**FINAL  
FIRST FIVE-YEAR REVIEW  
FOR THE  
ROCKWOOL INDUSTRIES, INC. SUPERFUND SITE  
BELTON, BELL COUNTY, TEXAS**

September 2012

REGION 6  
UNITED STATES ENVIRONMENTAL PROTECTION AGENCY  
1445 Ross Avenue  
Dallas, TX 75202-2733

**Figure 10. Erosion Damage and Repairs to Matcon Cap**

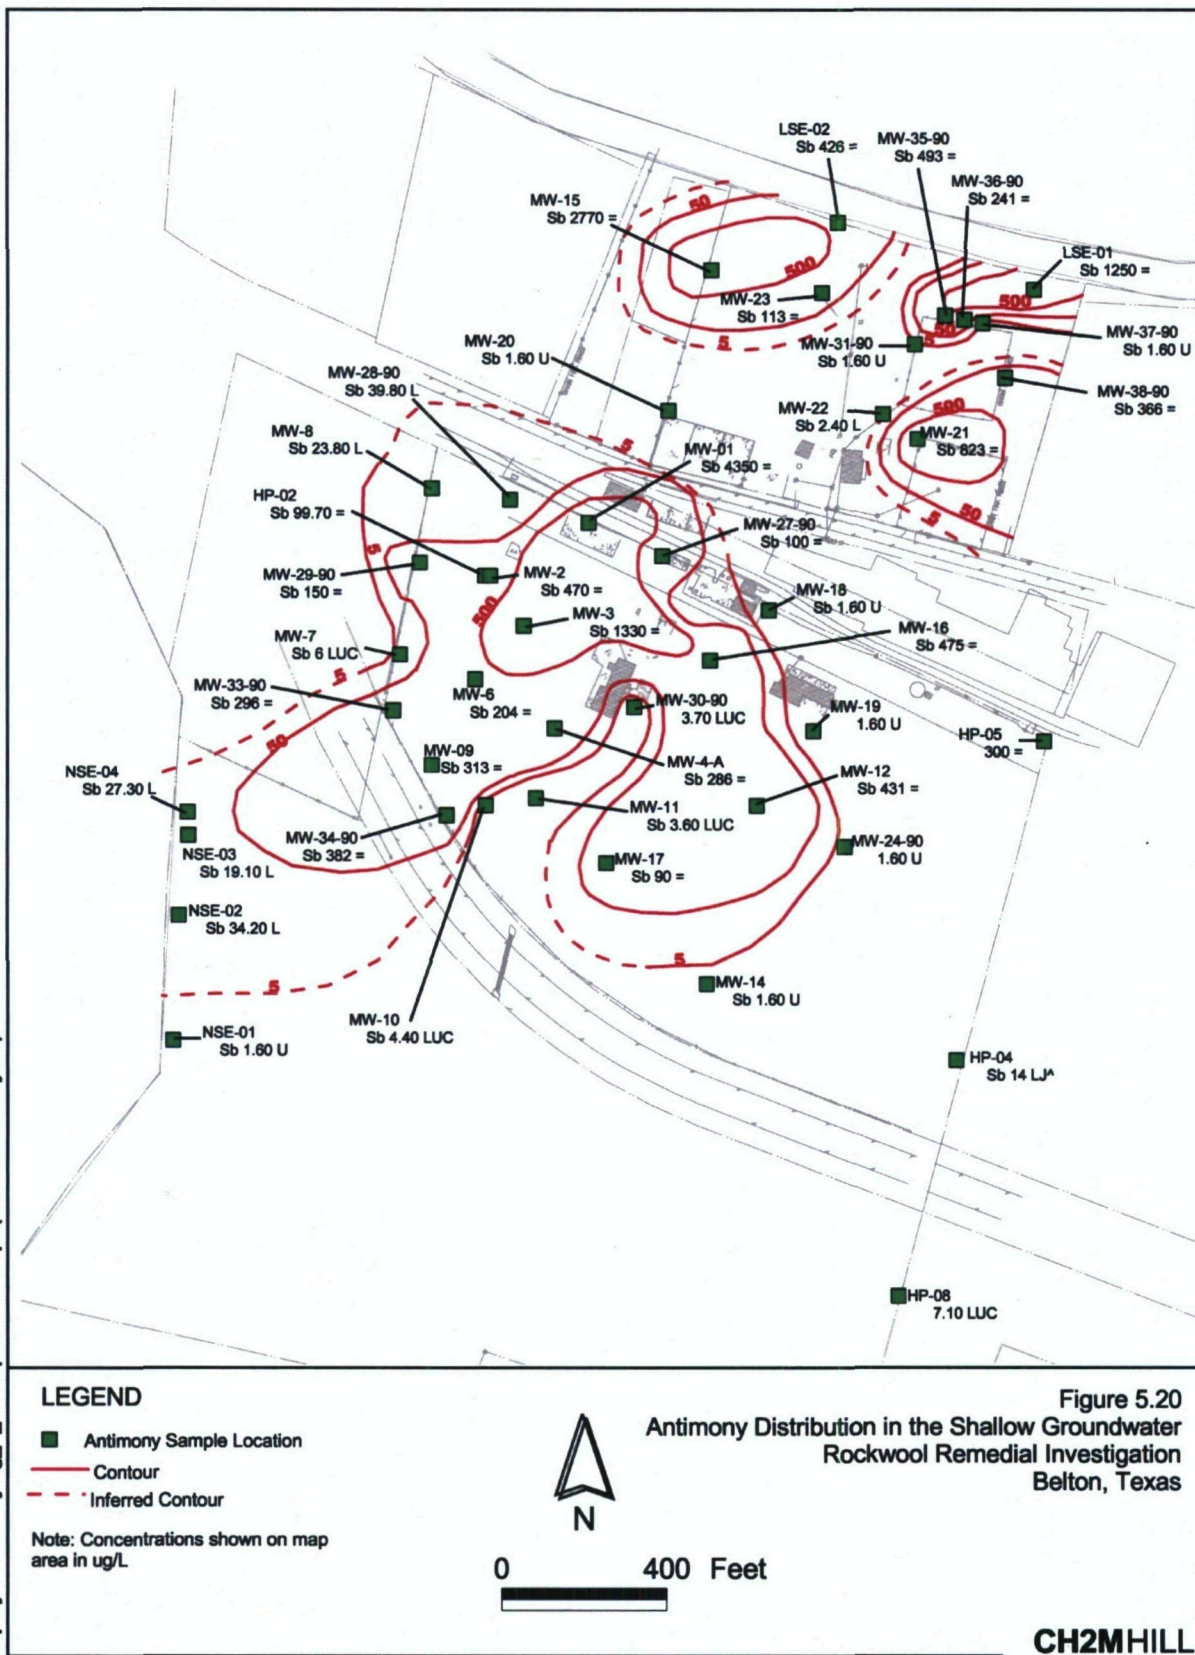
**In response to TCEQ observations of localized cracking of the asphalt perimeter located adjacent to the drainage ditch, the EPA conducted repairs to these areas in late 2010. It should be noted that the asphalt cover over the waste containment cell was determined by EPA to not be in need of repair (i.e., the integrity of the cover over the waste containment cell was not compromised).**

Photo 51. Small cracks in the cover on the top of NSP.

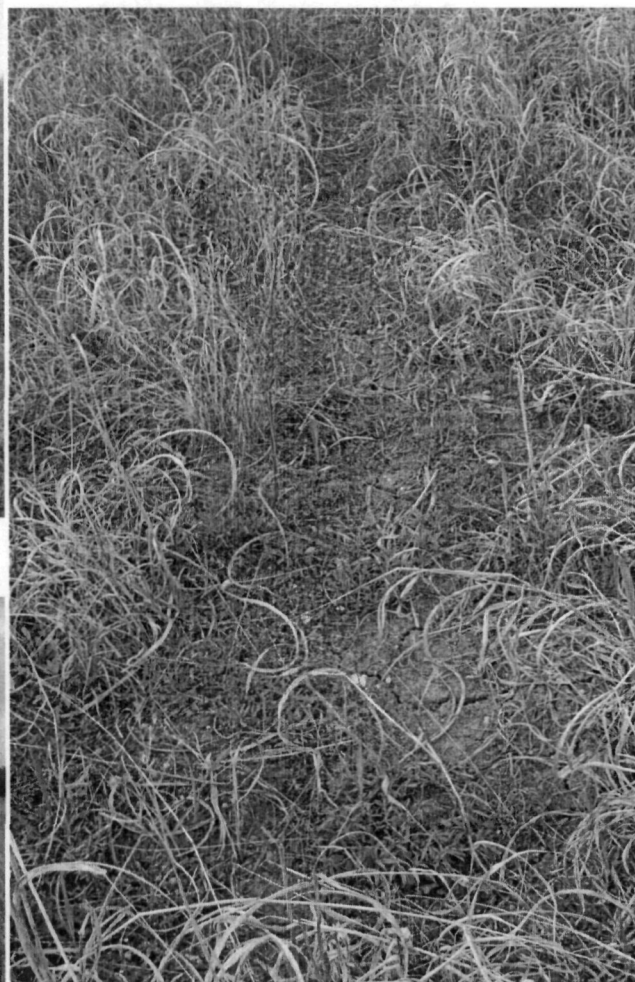
The cap over the CSP and NSP had good grass cover, except that there are some small cracks in the top of the NSP (**Photo 51**). The vegetation needs to be re-established in the western edge of the CSP where the concrete plant operations encroached on the cover. There was a good grass cover over the capped EVL. One area of active erosion was identified along the western edge of the EVL (**Photo 48**), and the erosion continued all the way north to the top bank edge of the ACB. This erosion needs to be addressed to avoid possible exposure of the waste placed in the EVL, and to avoid possible destabilization of the ACB stabilized LRB. Portions of the capped in place wastes and contaminated soils in the SSP area of the Central Property had areas of sparse vegetation (**Photos 72 and 73**). The vegetation needs to be re-established in these areas. Inspection of the ACB stabilized Leon River bank showed several of the ACBs had shifted at the toe of the bank between the EVL and the NSP (**Photos 39-42**). The ACB needs to be monitored to avoid loss of the blocks and erosion of the bank. There are small trees growing out of the ACB which need to be removed. There is a CMP pipe that discharges in the stabilized LRB between the NPS and the EVL that is partially clogged (**Photos 31 and 32**), and needs to be cleaned out. The concrete outfall for this pipe is cracked (**Photos 33 and 34**). These cracks are large enough to possibly allow water to flow under the outfall and should be repaired to avoid possible erosion and undermining of the outfall. There are two CMPs under the CSP. The inlet to one of these pipes is partially clogged (**Photo 55**) and should be cleaned out. On the North Property, wheel ruts were observed in the area between the EVL and the parking lot (**Photo 47**), but this is not an area with covered waste. These ruts were probably caused by city workers performing maintenance at the site.

Photo 69. Erosion protection mat has separated from the ground and is several inches above the bottom of the drainage ditch.

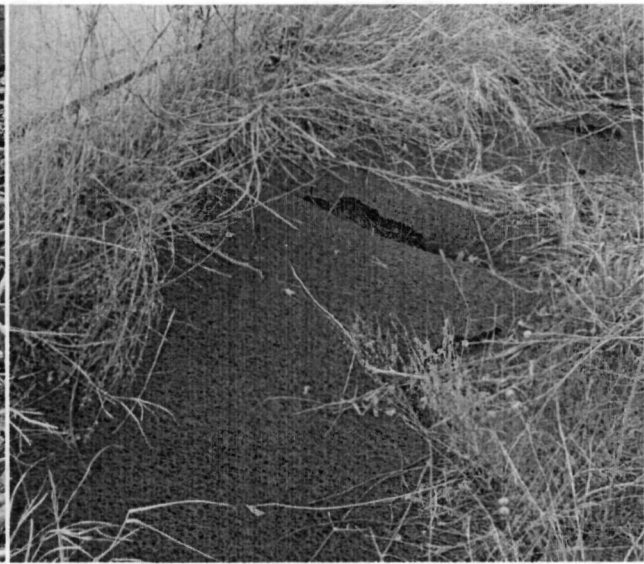
The Matcon cap had multiple small cracks in the asphalt, both sealed and unsealed, but the cracking did not appear excessive. Most cracking was around the perimeter of the cap. Unsealed cracks need to be repaired as specified in the O&M Plan (**CH2M HILL, 2006**). The repairs made to the erosion along southern edge of the cap were noted (**Photos 62-65**), and at one location it appears that there may be new erosion forming in the rip-rap repaired area (**Photo 63**). **Figure 10** shows an example of the previous erosion damage and the repairs along the southern edge of the cap. When the CC was constructed, a green fibrous erosion control matting was placed in the drainage ditch around the perimeter of the cell. At places, the matting has separated from the ground and is now suspended several inches above the ditch (**Photo 69**). The matting

should be reinstalled as intended by the original. At several places around the edge of the asphalt Matcon cap it appears that there is minor erosion of the cap subbase occurring beneath the erosion control matting (**Photos 66-68**). The cap extends past the edge of the containment cell by seven feet (**Figure 9** shows the design of the CC), and there is no near term risk of the waste being exposed, but the erosion of the subbase needs to be addressed prior to undermining and damage to the edge of the Matcon cap to avoid expensive repairs.

Photo 73. Sparse vegetation cover over SSP waste capped in place.

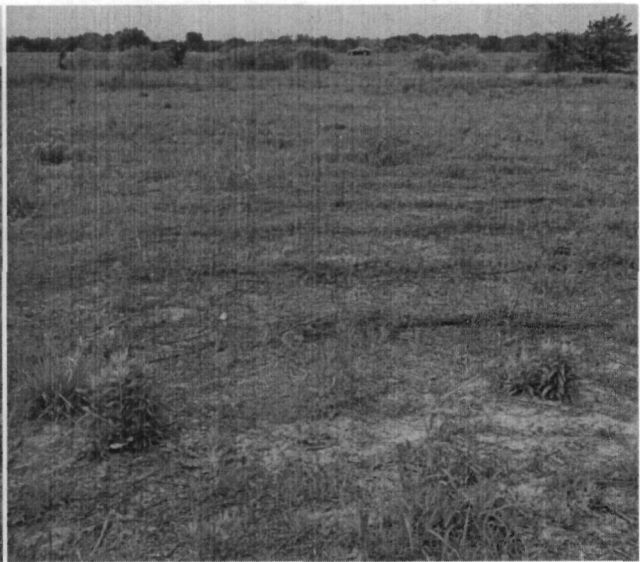
7.	In areas with capped waste and with sparse vegetation the vegetation needs to be re-established to provide erosion protection.	TCEQ	EPA	N	Y
8.	The erosion near the edge of the capped EVL should be repaired and addressed in a manner to reduce or prevent future erosion.	EPA	EPA	N	Y
